Town of Parker Community Development Department  
 Development Review Division  
 Attention: **BrieAnna Simon**

Application Type: **Site Plan**  
 Status: **First Referral**  
 Application Name: **Douglas 234 F6 AMD 1 L3 – McDonalds**  
 Case/AP#: **SP21-067**  
 Referral Received: July 14, 2021  
 Comments Due: August 12, 2021

Review date: **August 2, 2021**  
 Plan reviewer: **Randall L. Capra, [rcapra@parkeronline.org](mailto:rcapra@parkeronline.org)**  
 Phone: 303.805.3169

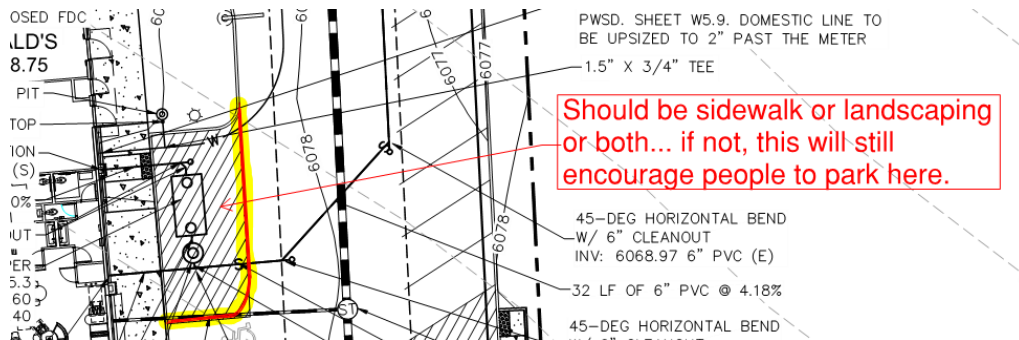
7. The applicant shall provide an auto turn analysis indicating that apparatus can navigate all portions of this site; NO PARKING – FIRE LANE signage is required for any portion of the access where the 20-foot clear width requirement cannot be met. *Satisfied; applicant has noted/acknowledged/addressed with current submittal.*
8. The Town of Parker requires that fire apparatus access roads meet the clear-width and weight-bearing standards of the jurisdiction in which the project is located. Roadways shall be designed to support the imposed weight of fire apparatus, 30 two axle and 40 ton three axle vehicles. An unimpeded clear width of 24-feet shall be maintained at all times. As such, any location where parked vehicles would obstruct this clear width requirement will require "NO PARKING – FIRE LANE" signage. *This signage shall be red on white. Update design criteria has been*

provided at the end of this document; ensure compliance when resubmitting. *Satisfied; applicant has noted/acknowledged/addressed with current submittal.*
